AGENDA
Planning & Zoning Commission
Tuesday, July 5, 2016
6:00 P.M.

DR16-03 Sylvan Circle Development Plan

CERTIFICATE OF RECOMMENDATION

PROJECT NAME: Sylvan Circle Major Development Permit

C TOWNHOUSE 'D' - WEST ELEV AT BLOCK 'A'
1/8" = 1'-0"

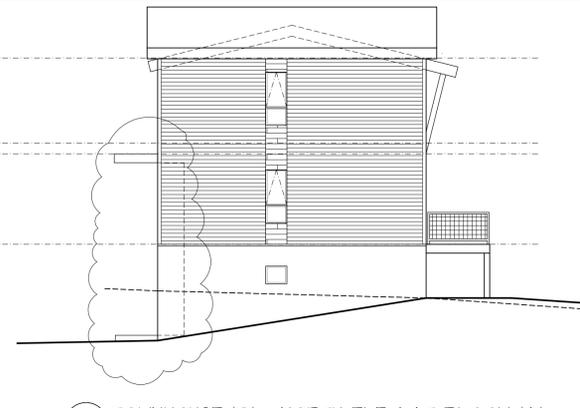
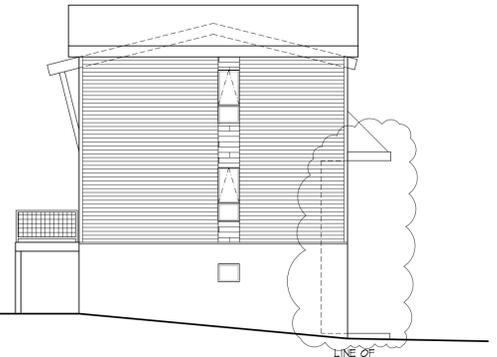
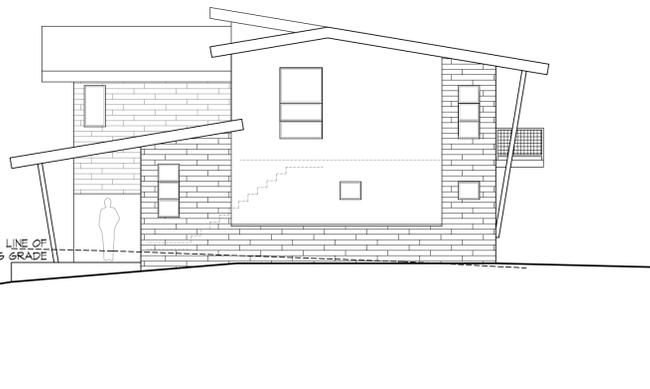
3. Removal of patios from water and sewer easement. These patios should also be buffered from the access road. Applicant should evaluate strategies on how this might be best

accomplished to provide a transition from the private patio space to the more public access drive. One idea is to use the fence railing detailing of the second story patios.

- 3) Removal of patios from the water and sewer easement.
 - a. The design of the units in Building A have been modified so that the entry roofs are cantilevered and the column has been removed. The bottom of the entry roof is 16'-6" above grade. All structural elements will be out of the easement, however, the entry patio will remain. We will coordinate with Town Engineering to address their concerns and come up with a solution that is agreeable to them. The architectural Elevations for Building A (Unit Type D) have been modified.

1 LANDSCAPE PLAN
SCALE: 1" = 30'-0"

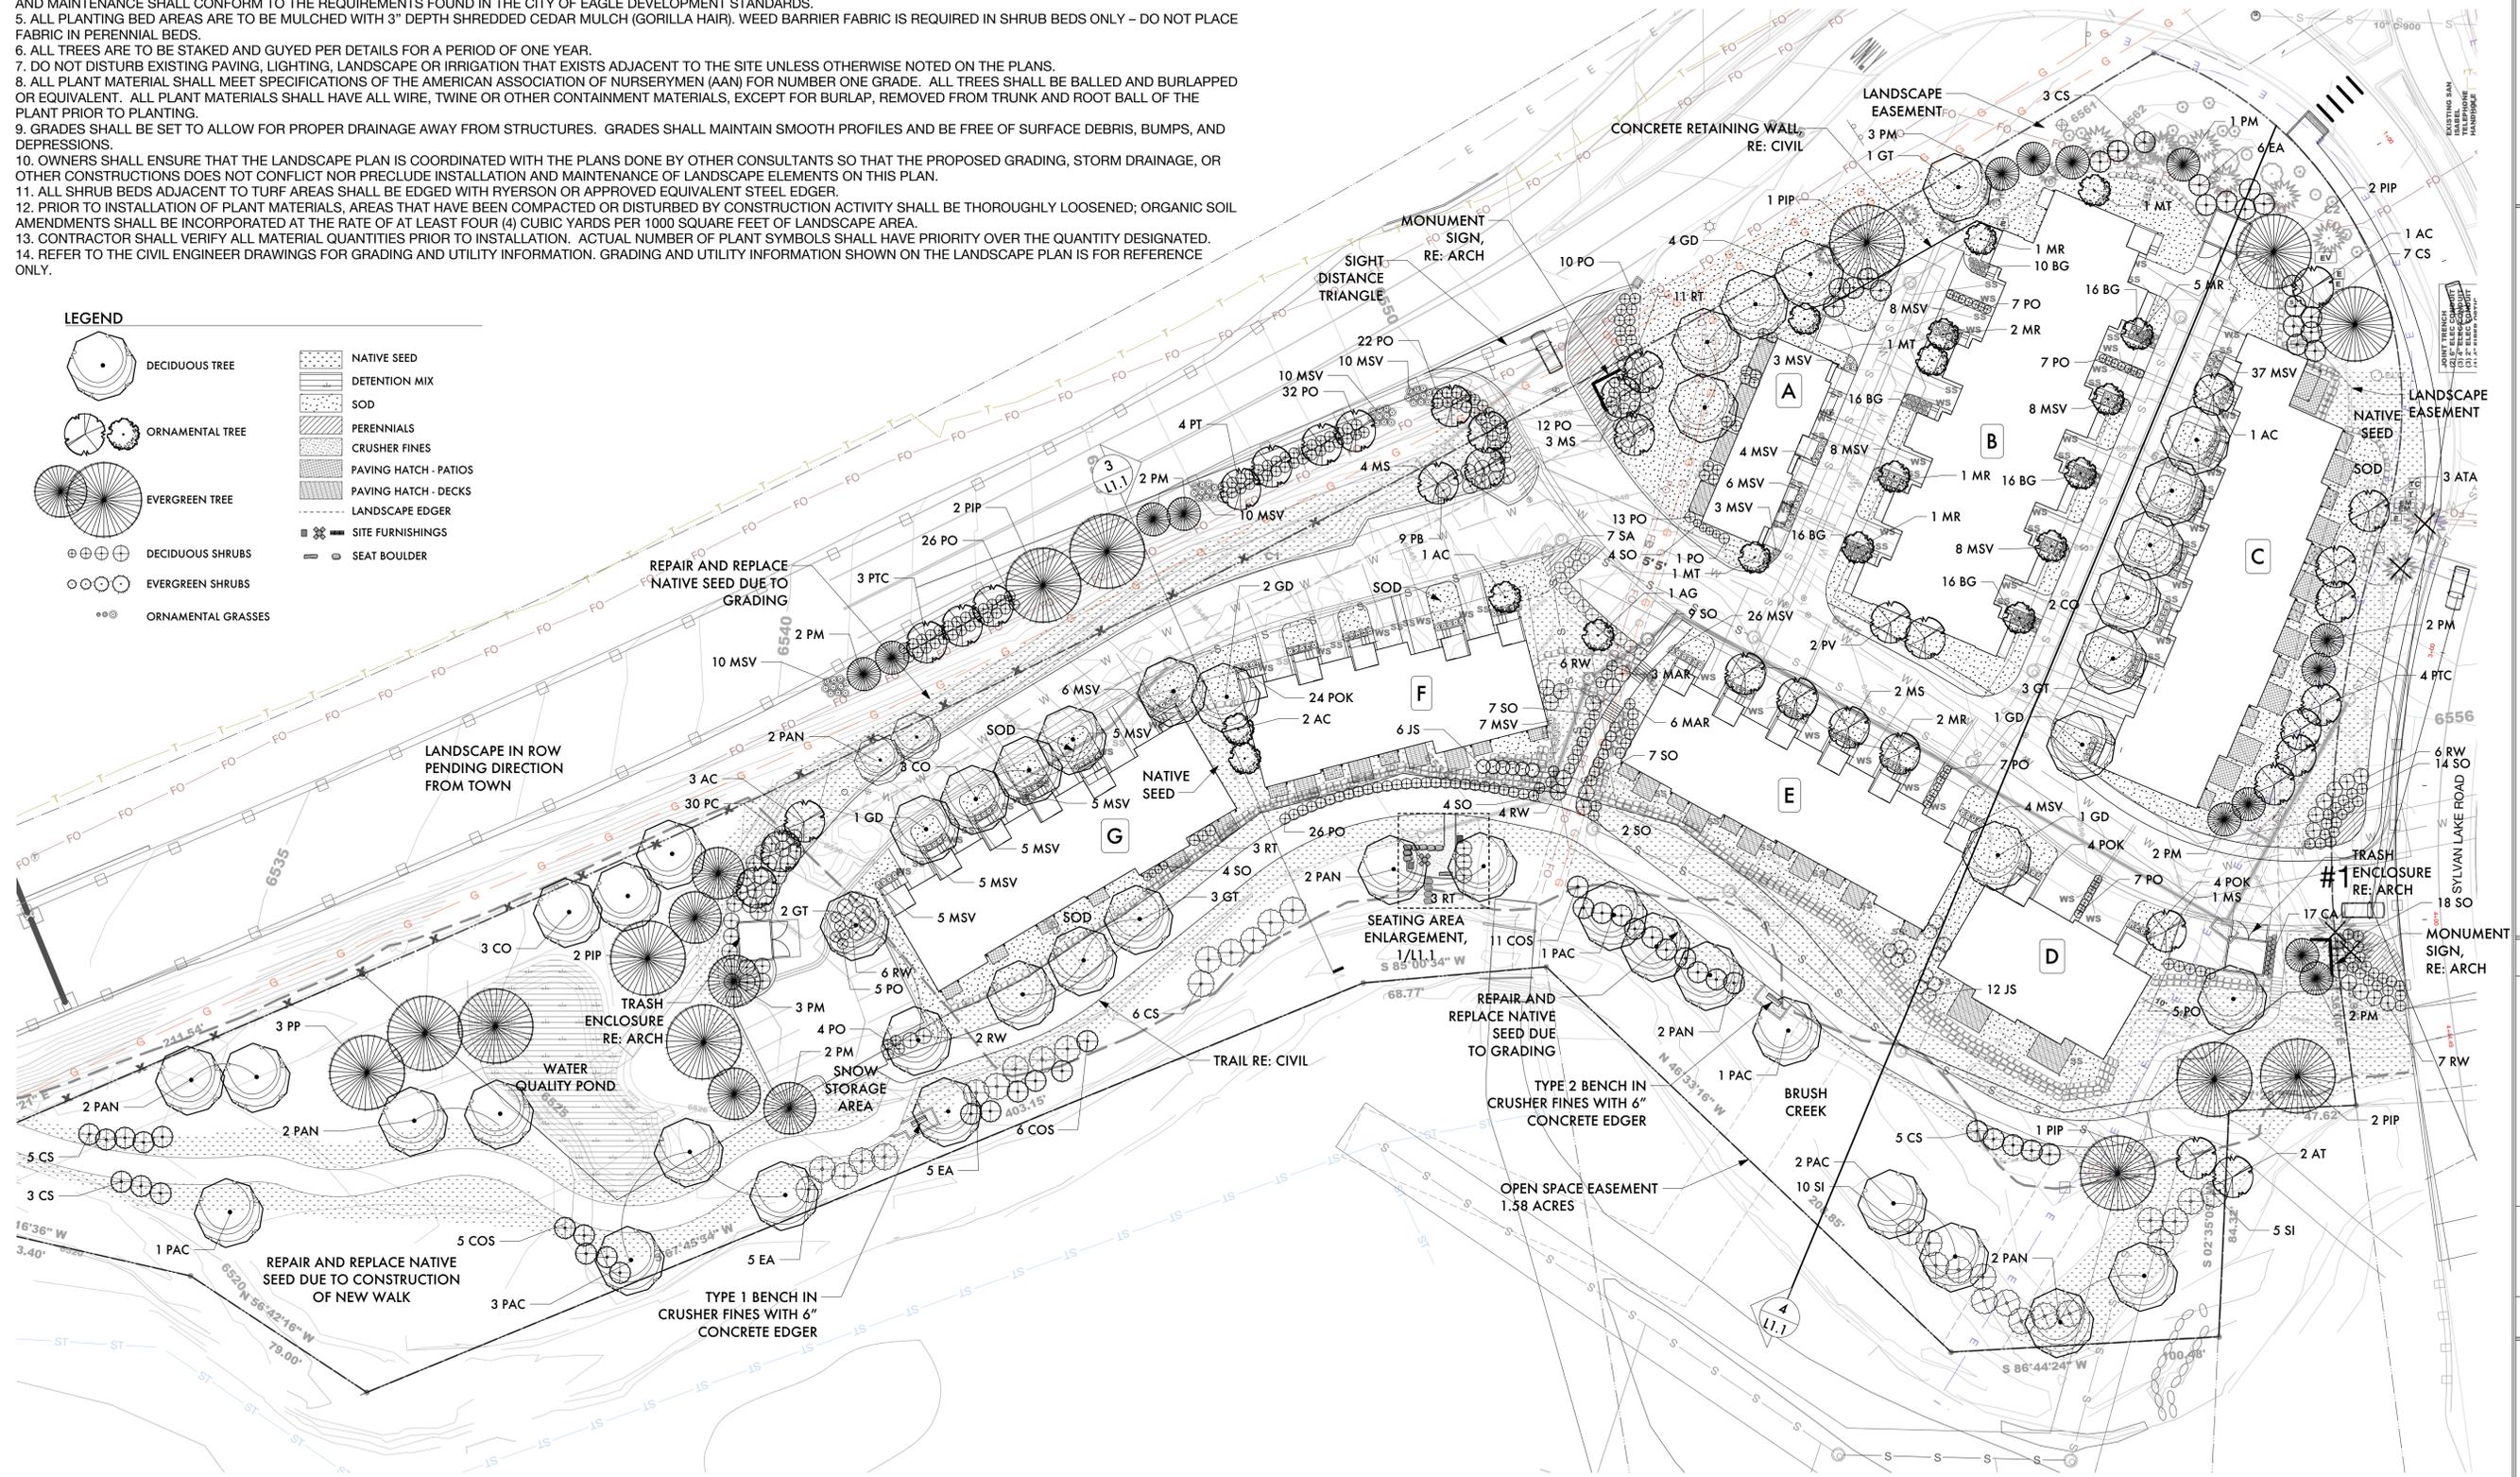
1. Additional landscape treatment along the back side of the Eagle Ranch Landscape Easement to buffer the development from the surrounding roadway. Incorporation of a stone wall with additional trees and bushes should be evaluated. This would provide a more managed transition from the more intensively used roundabout and the Development. It would contribute to the visual quality experienced by travelers approaching this key intersection and also provide a valuable sense of privacy to the residences of the development. This is one of the key planning considerations for this property when evaluating how this land use fits into its context. The buildings are lower than the surrounding landscaping and need a better transition.

10. Placement of trees need to be evaluated to ensure they are not located in water and sewer easements.

1. Requested that the applicant add evergreen trees to the buffer along highway 6 to better screen the development from the highway.

Staff has discussed this concern with the applicant and he has indicated a willingness to add more buffering. Please see revised Landscape Plan attached as part of Exhibit D submitted on Friday. Staff will comment at the Hearing as to its effectiveness.

- 1) Addition landscape treatment along and/or within the Eagle Ranch landscape easement.
 - a. The Landscape Plan has been revised to add additional bushes and shrubs to create a denser screen along that edge. More trees along the north are not possible, as the current layout maximizes the amount of trees that can be placed along the northern portion of the easement without the mature tree canopies conflicting.

Trees and shrubs have been added on the eastern end of the easement. The effect will be denser and more layered landscape screen between the road and the buildings. Overall, more landscaping has been added within the Eagle Ranch Easement. Prior conversations with the Eagle Ranch HOA administrator and the DRB administrator indicated that augmentation of the existing landscape easement would be acceptable, but would require DRB review once the Town was satisfied with the proposal.

- 10) Placement of trees to be evaluated to ensure that they are not located in water and sewer easements.
 - a. All trees have been moved out of the water and sewer easements and the modification is reflected on the Landscape Plan.

- 1) Provide evergreen trees along south side of Highway 6 in tree grouping.
 - a. Revisions have been made to Landscape Plan. The trees have been changed to a mix of evergreens and aspens and tall ornamental grasses have been added. The Landscape Architect has confirmed that the landscape proposed is expected to survive the winter road treatment of cinders.
- 2) Provide additional section cut through site.
 - a. Refer to Landscape Plan 4/L1.1. (The retaining wall on the east side of Building C was removed, so we didn't provide a section through that area and extending to Building A).

2 WOOD BENCHES ALONG TRAIL

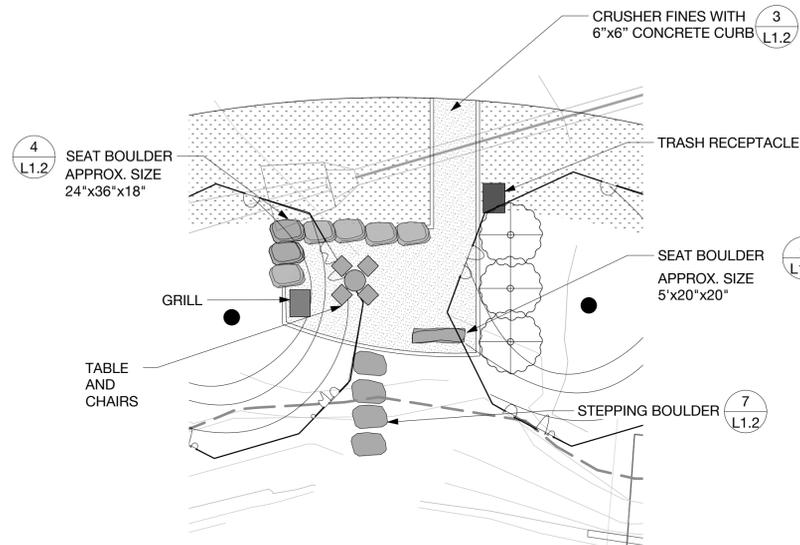
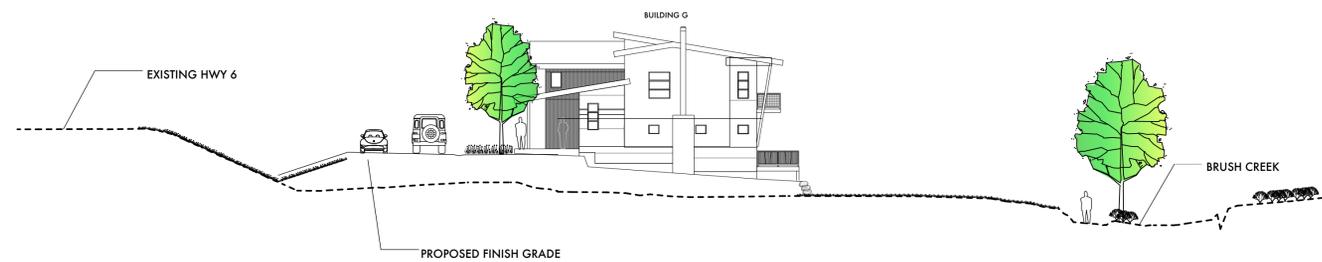
2. Placement of one or two benches with shade trees along the proposed creek-side path.

- 2) Placement of benches in the Open Space easement.
 - a. Two benches have been added to the Landscape Plan. Refer to images of proposed design on Landscape Plans 2/L1.1.
